PRIVATE PLAN CHANGE 48: DRURY CENTRE PRECINCT – KIWI PROPERTY HOLDINGS

PRIVATE PLAN CHANGE 49: DRURY EAST PRECINCT – FULTON HOGAN LAND DEVELOPMENT LTD

PRIVATE PLAN CHANGE 50: WAIHOEHOE PRECINCT – OYSTER CAPITAL

JOINT WITNESS STATEMENT (JWS) OF EXPERTS IN RELATION TO STORMWATER (TECHNICAL)

Figure 1: Flooding and overland flow paths within the Waihoehoe Precinct and railway culvert

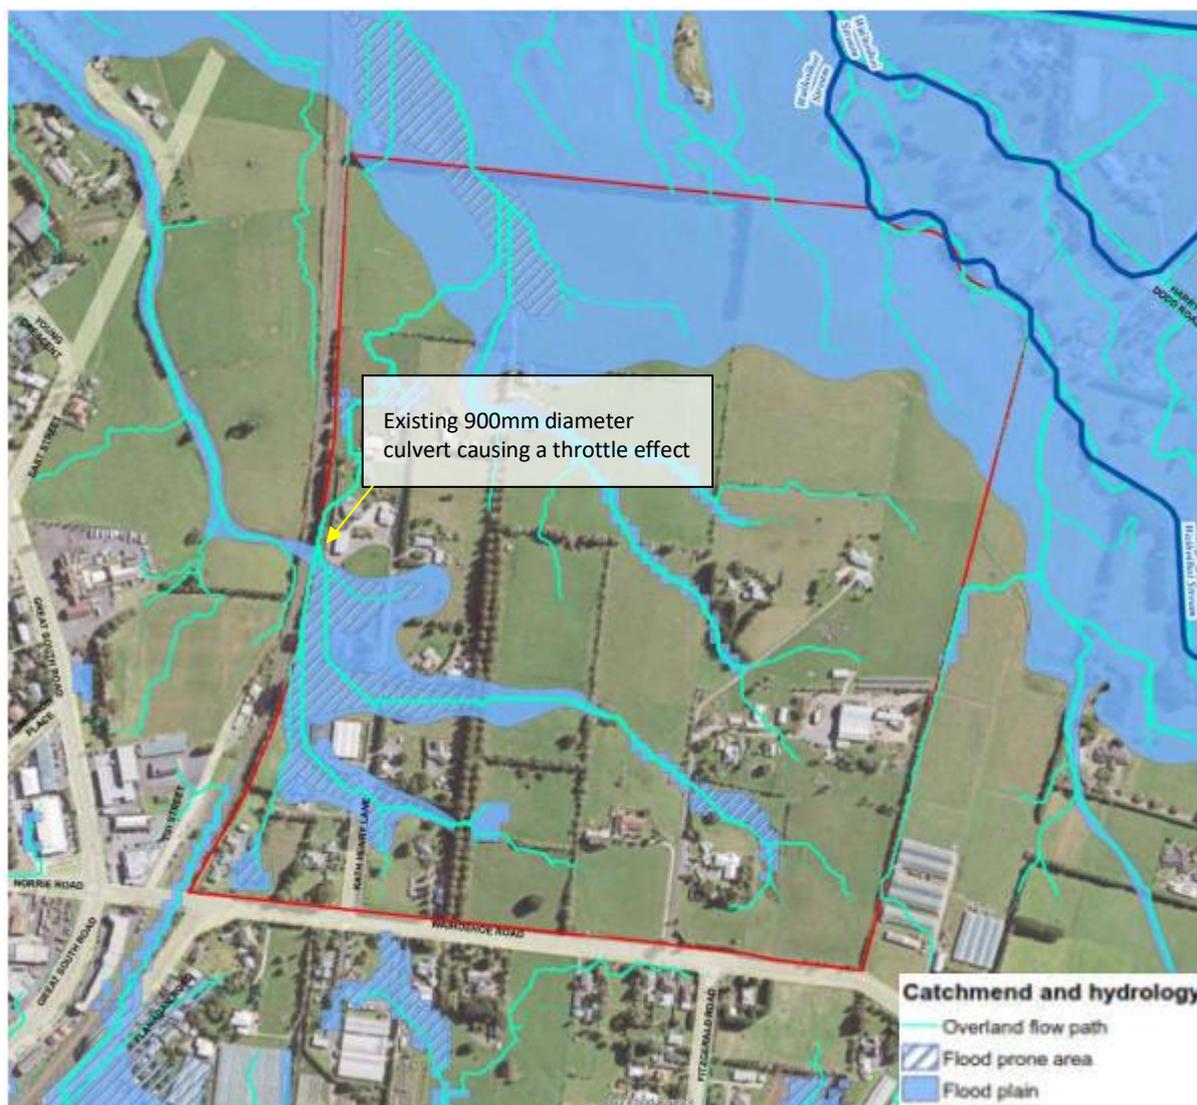
4.3 The applicants are to add an overlay of the location of the attenuation basins, relative to the floodplain at Figure 1 of the memo (Appendix A); and to further clarify the text in Section 4.4.6 lag times.
